C2074 CHINESE BIG5 (TRADITIONAL) FIRMWARE RELEASE NOTES

WM-Nano Table Top Automatic Wrapper with PK-260B CPU Board

Version C2074 features & changes [27 April 2016]

PK-260B with SD Memory Card Slot

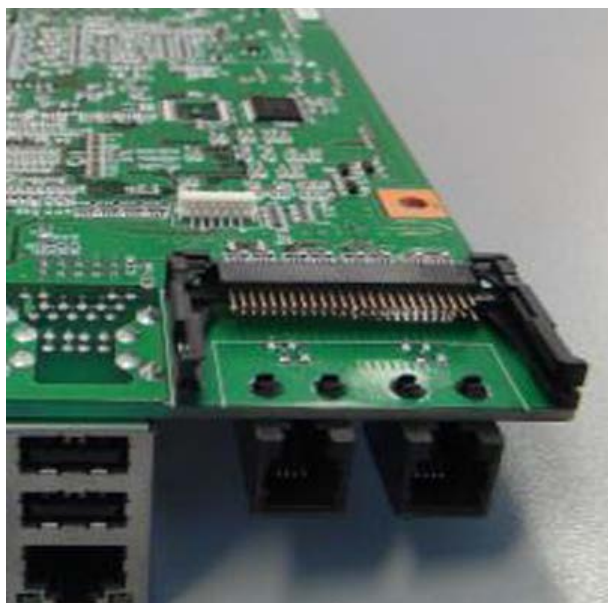
Firmware B0760x is designed for the revised CPU board PK-260B. **This firmware is not compatible with the previous CPU board PK-260A.** And previous firmware (B0684x, etc.) is not compatible with the new PK-260B CPU board.

The two CPU board versions can be easily identified by the expansion memory card slot located on the left side of the Uni-7 controller. See the images below.
